INDEPENDENT ORBITER ASSESSMENT

**FMEA/CIL
ASSESSMENT
INTERIM REPORT**

9 MARCH 1988

WORKING PAPER NO. 1.0-WP-VA88003-40

Figure C.2b - RSB ACTUATOR ASSESSMENT

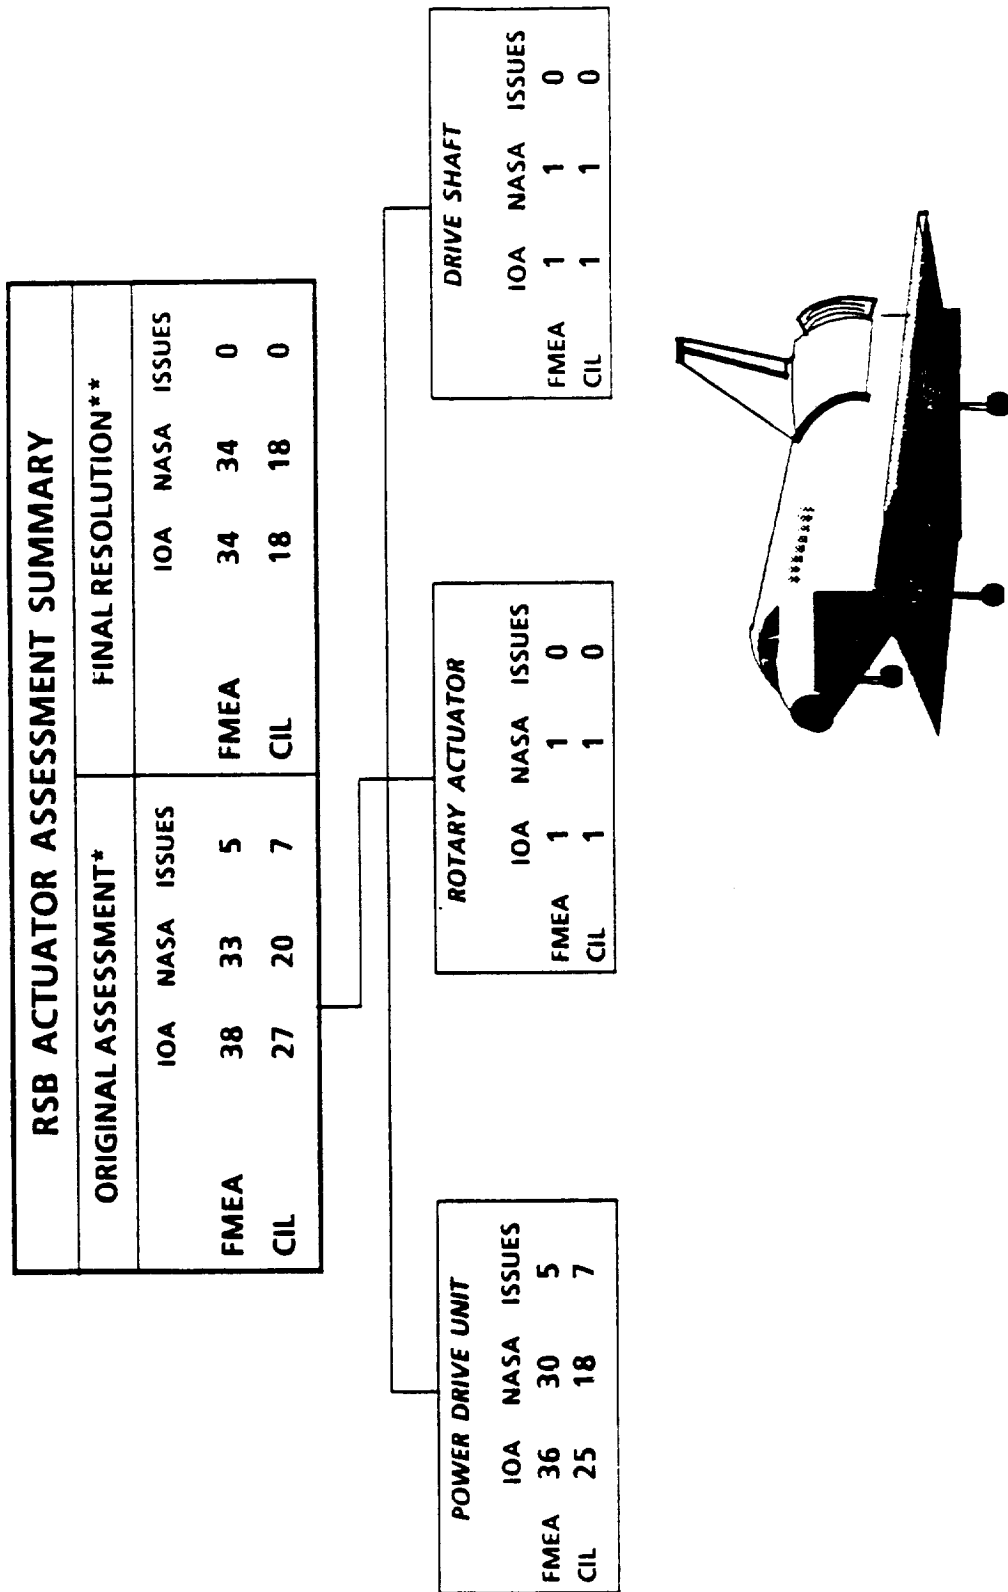
The overview in Fig. C.2b is a summary of the RSB actuator assessment and presents a comparison of the Pre 51-L baseline and the proposed Post 51-L baseline, with the IOA recommended failures, and any issues. The main reason for differences was that NASA combined failures, whereas IOA prepared separate failure worksheets. Minor differences such as fail or pass of screens were readily resolved. As the result of discussions with the Subsystem Manager and review of the updated FMEA/CIL, all initial issues were resolved and changes were made to the FMEA/CIL and IOA worksheets. The overview further shows the comparison of failures of the major elements of the RSB actuators.

The IOA effort first completed an analysis of the Rudder/Speed Brake (RSB) hardware, generating draft failure modes and PCIs. To preserve independence, this analysis was accomplished without reliance upon the results contained within the NASA FMEA/CIL documentation.

The IOA analysis of the RSB hardware initially generated 38 failure mode worksheets and identified 27 PCIs before starting the assessment process. No additional failure mode worksheets were generated during the comparison. The IOA results were then compared to the NASA FMEA/CIL baseline along with the proposed Post 51-L CIL updates included. A resolution of each discrepancy from the comparison was provided through additional analysis as required. Upon completion of the assessment, all of the IOA and NASA failure modes were in agreement.

Figure C.3 - D&C OVERVIEW ASSESSMENT

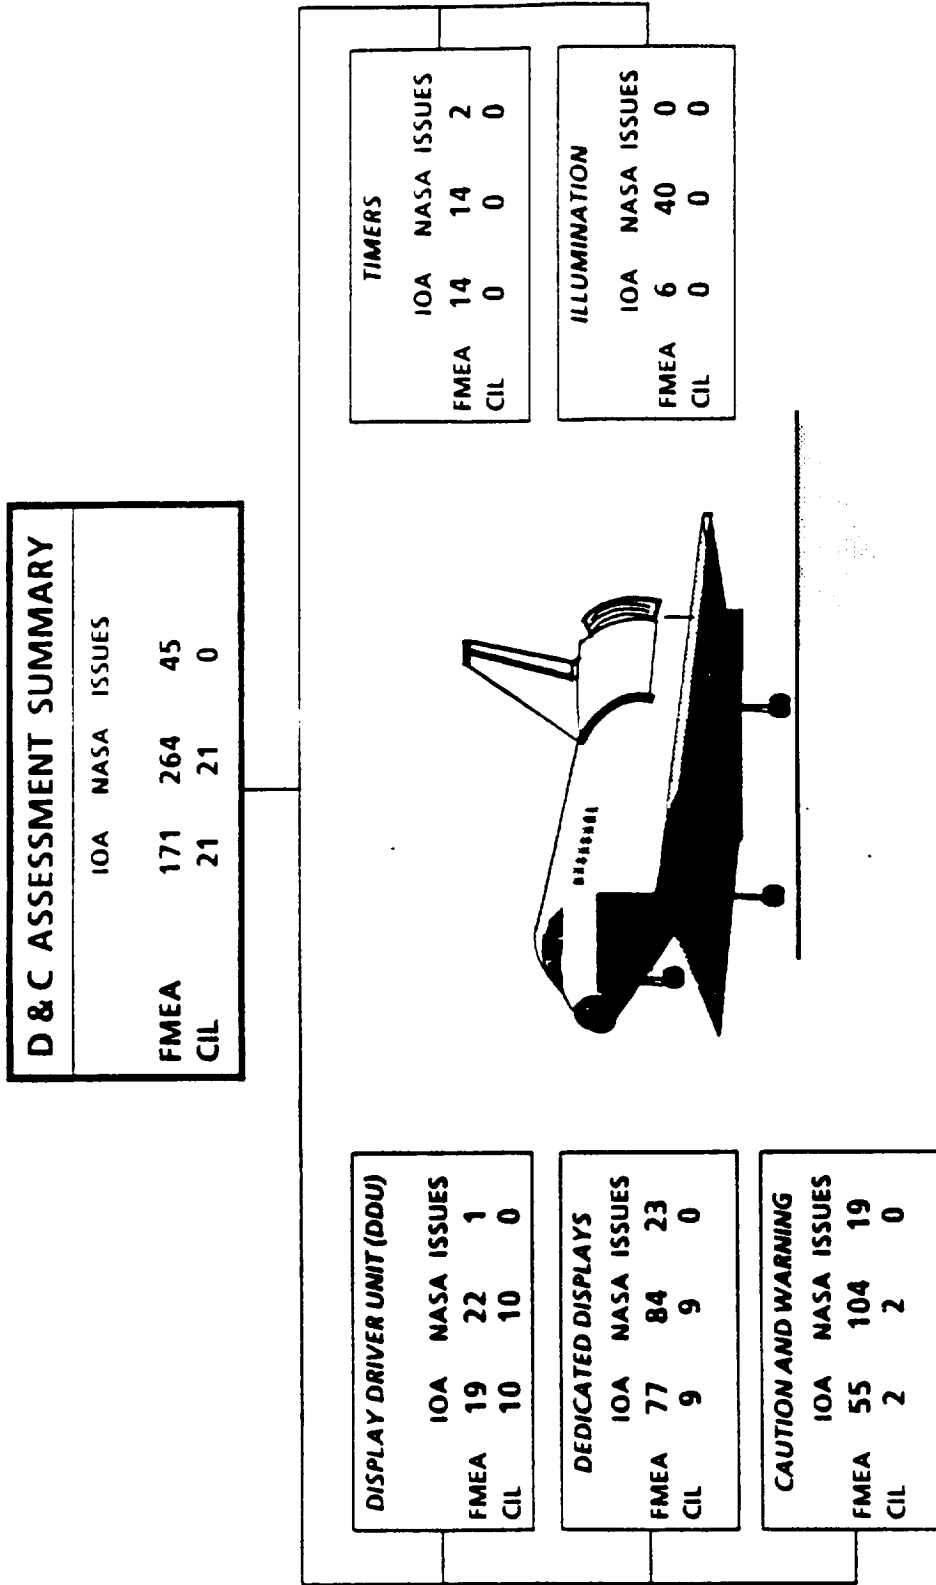
The IOA product for D&C analysis consisted of 134 failure mode worksheets that resulted in 8 PCIs being identified. In order to facilitate comparison, 37 additional failure mode worksheets were generated. Comparison was made to the NASA baseline of 4 January 1988, which consisted of 264 FMEAs and 21 CIL items. The comparison determined if there were any results which had been found by the IOA but were not in the NASA baseline. This comparison produced agreement on all but 45 FMEAs, which caused no differences in the CIL items. Reference Figure C.3.

The issues arose due to different interpretation of NSTS 22206, FMEA and CIL preparation instruction. IOA analyzed the electrical circuit as a black box, and NASA analyzed the components of the black boxes. Of the 45 differences with the FMEAs, all were minor and did not affect criticalities assessment. In conclusion, IOA is in full agreement with the revised NASA CIL baseline.

Figure C.4a - GNC FMEA/CIL ASSESSMENT

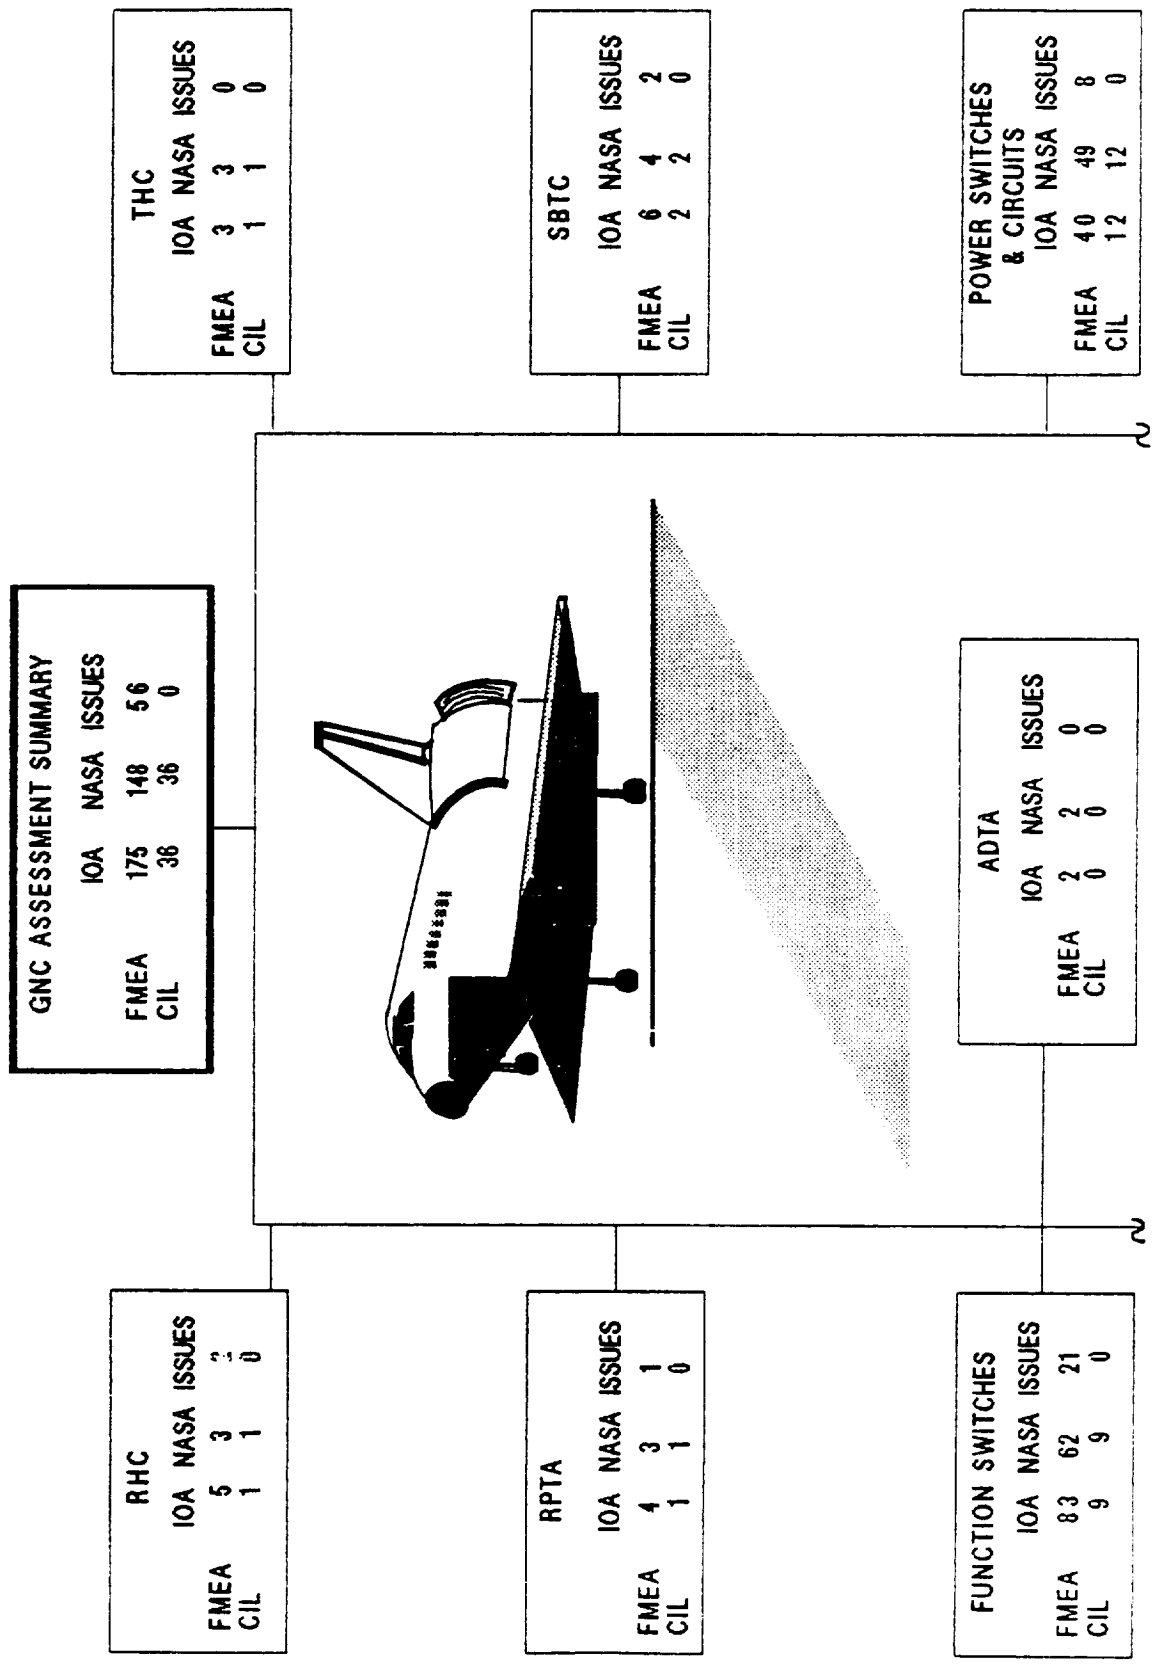
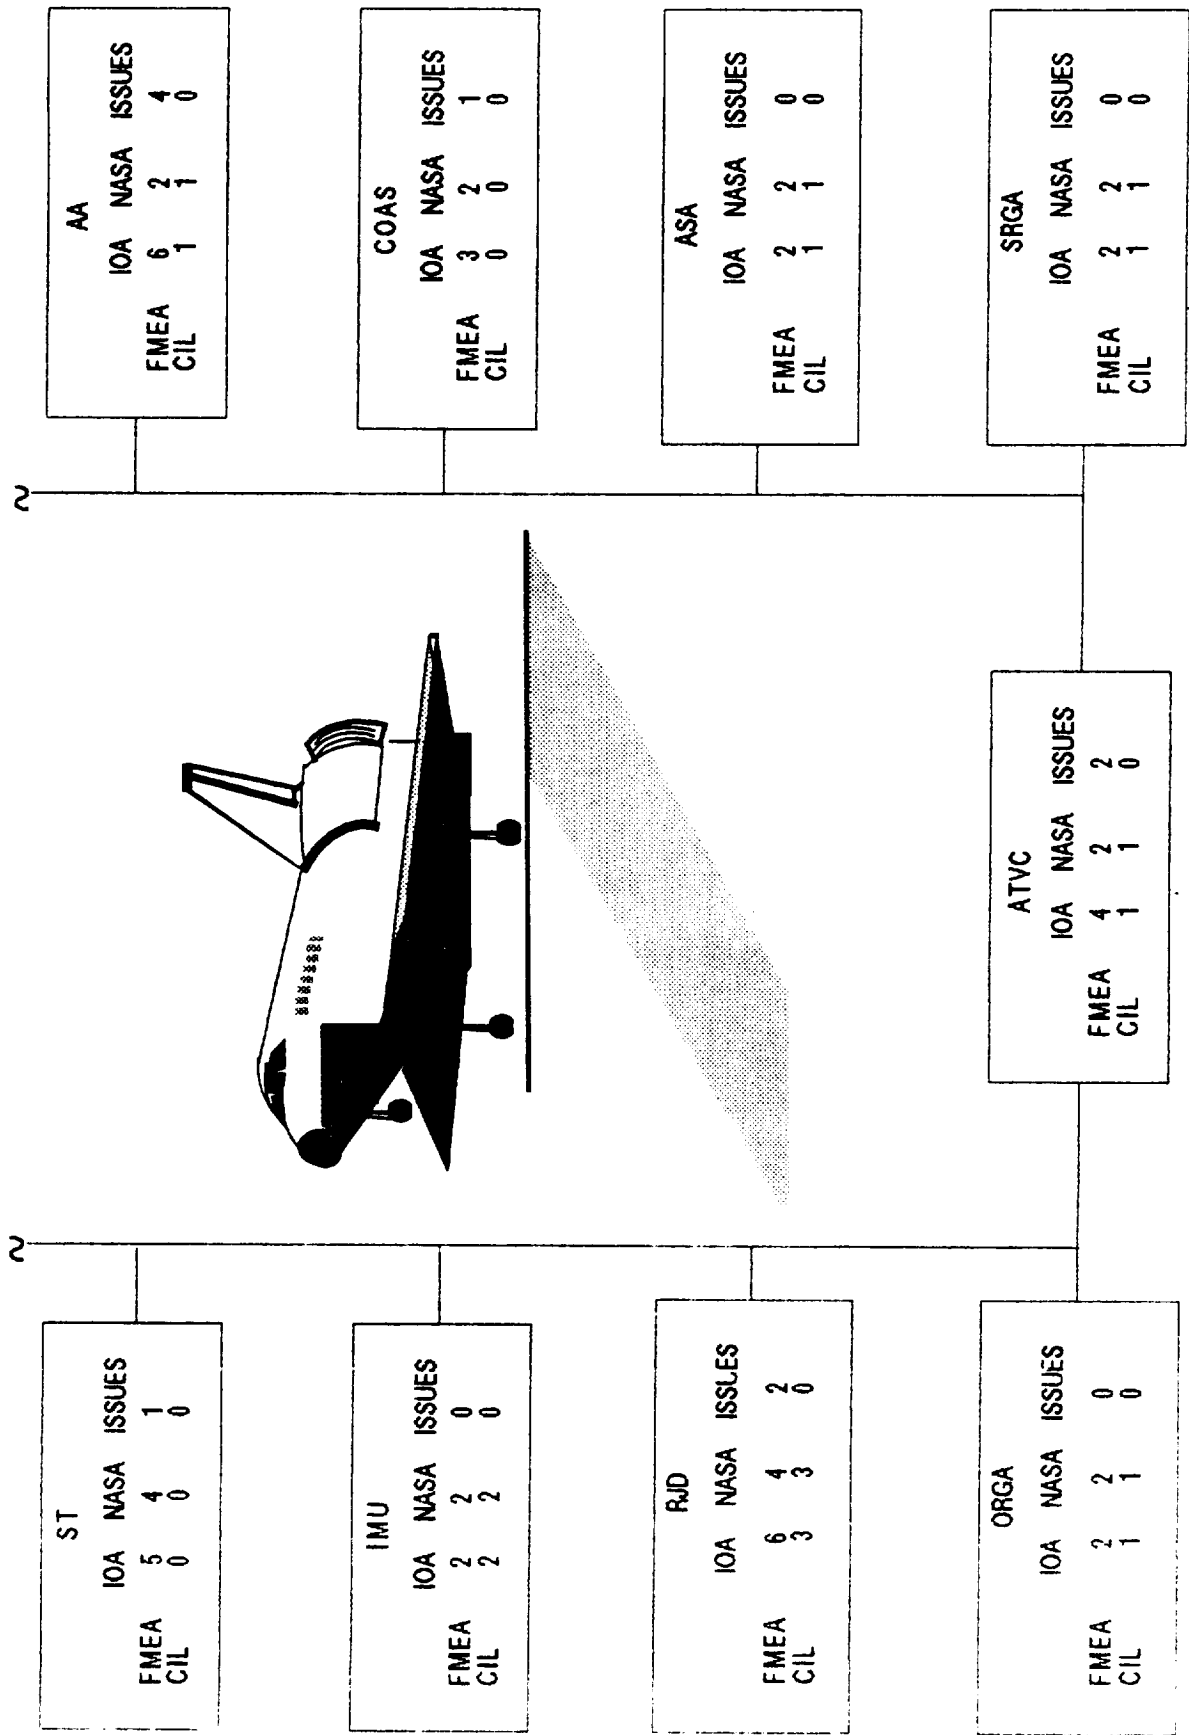
The IOA product for the GNC analysis consisted of 141 failure mode worksheets that resulted in 24 PCIs being identified. In order to facilitate comparison, 34 additional failure mode worksheets were generated. Comparison was made to the NASA baseline (as of 4 January 1988) which consisted of 148 FMEAs and 36 CIL items. The comparison determined if there were any results which had been found by the IOA but were not in the NASA baseline. This comparison produced agreement on all but 56 FMEAs, which caused differences in zero (0) CIL items. Reference Figure C.4a & b.

The issues arose due to different interpretation of NSTS 22206, FMEA and CIL preparation instructions. IOA analyzed the components of the electrical circuits, generating 56 worksheets more than NASA, who treated the electrical circuits as black boxes. Of these 56 differences with the FMEAs, all were minor and did not affect criticalities assessments. Three (3) of the FMEAs' issues were with the SRB RGA's EPD&C. No drawings were available to assess these FMEAs. In conclusion, IOA is in full agreement with the revised NASA CIL baseline.

Figure C.7 - BFS FMEA/CIL ASSESSMENT

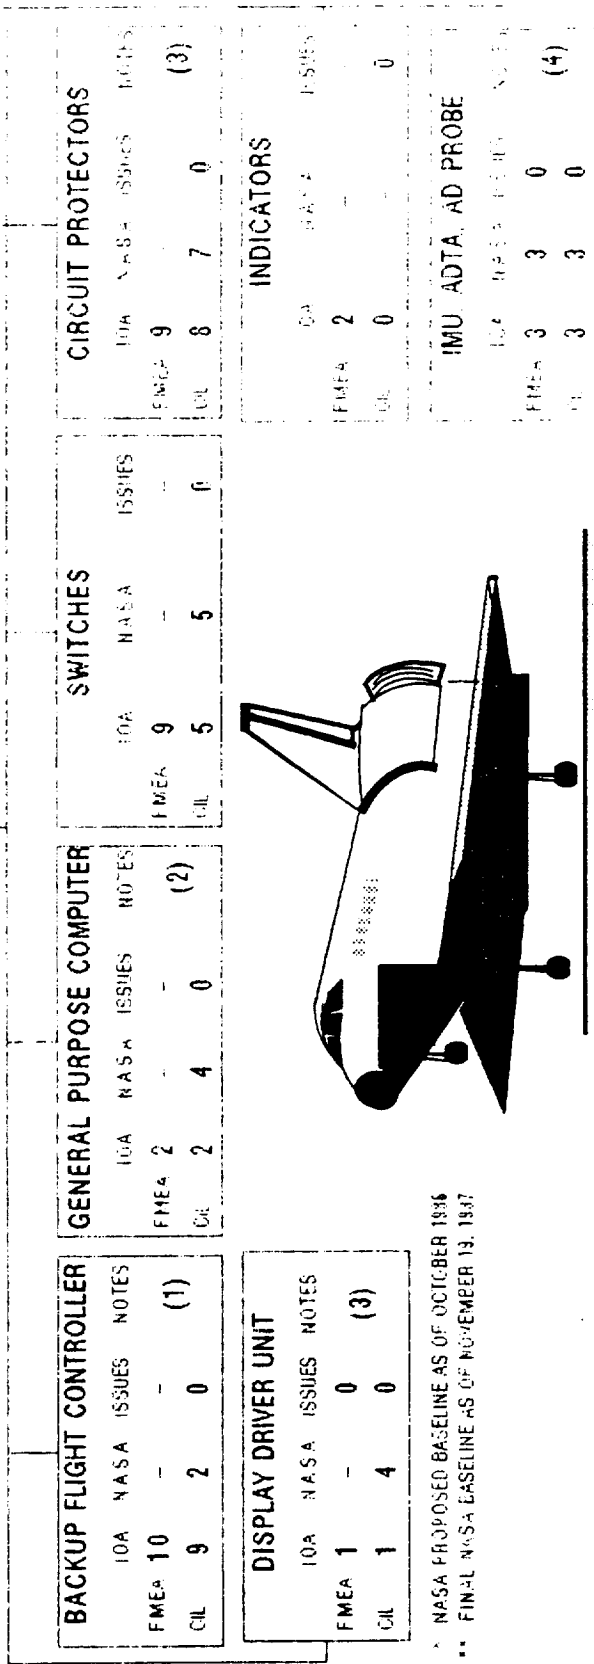
The original assessment determined there were numerous failure modes and PCIs in the IOA analysis that were not contained in the NASA BFS baseline. Conversely, the NASA baseline contained 3 FMEAs (IMU, ADTA, and Air Data Probe) for CIL items that were not identified in the IOA product. The IOA prepared worksheets and agreed with the NASA analysis for the 3 items. This increased the IOA worksheets from 29 to 32 and the PCIs from 21 to 24 for the original assessment as shown in Figure C.7.

a substantial rewrite of all CILs between December 1986 and November 1987. This effort included eliminating BFS as a unique subsystem by integrating BFS CILs with primary DPS CILs. The revised NASA baseline contained 4 more FMEAs for CIL items that were not identified in the original IOA BFS product, deleted the IMU CIL related FMEA mentioned in the previous paragraph, and moved the ADTA and Air Data Probe CILs also mentioned in the previous paragraph, to the GN&C subsystem. Once again, the IOA prepared worksheets and agreed with the NASA analysis of the additional failures. This increased the IOA worksheets from 32 to 33 and the PCIs from 24 to 25 for the final assessment. The IOA assessment of the final updated baseline (19 November 1987) results in agreement on all BFS CIL items, even though there are differences in number of items and assigned criticalities. Figure C.7 presents an overview of the assessment results.

The differences in assigned criticalities are due to different interpretation and application of the FMEA/CIL preparation instructions contained in NSTS 22206. The IOA analyzed BFS hardware failures with the assumption the BFS had been or would be engaged. NASA analyzed BFS hardware failures as an integral part of the DPS or EPD&C and, therefore, counted generic PASS failures when assigning criticalities to BFS hardware failure modes. The IOA interpretation neither added to, nor subtracted from the CIL.

Figure C.9 - LDG/DEC ASSESSMENT

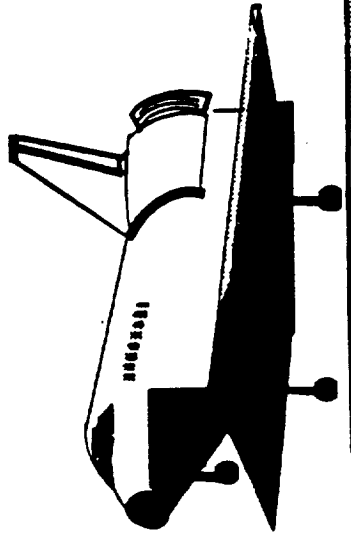
failure mode worksheets that resulted in 16 PCIs being identified. A comparison was made of the IOA product to the NASA FMEA/CIL dated 20 November 1987, which consisted of 42 FMEAs and 8 CIL items. The difference in the number of IOA analysis worksheets and NASA FMEAs can be explained by the different levels of analysis detail performed to identify failure modes. The comparison determined if there were any results found by the IOA that were not included in the NASA FMEA/CIL.

The assessment produced agreement on all but 5 failure modes. Three (3) failure modes for components were not identified by the NASA FMEAs, 1 being a CIL item. Two (2) failure modes were identified by IOA and NASA which have differences in criticality resulting in 2 new CIL items. Figure C.10 presents a comparison of the proposed Post 51-L NASA FMEA/CIL baseline with the IOA recommended baseline and any issues. Detailed discussion of IOA issues and recommendations are provided in subsequent paragraphs.
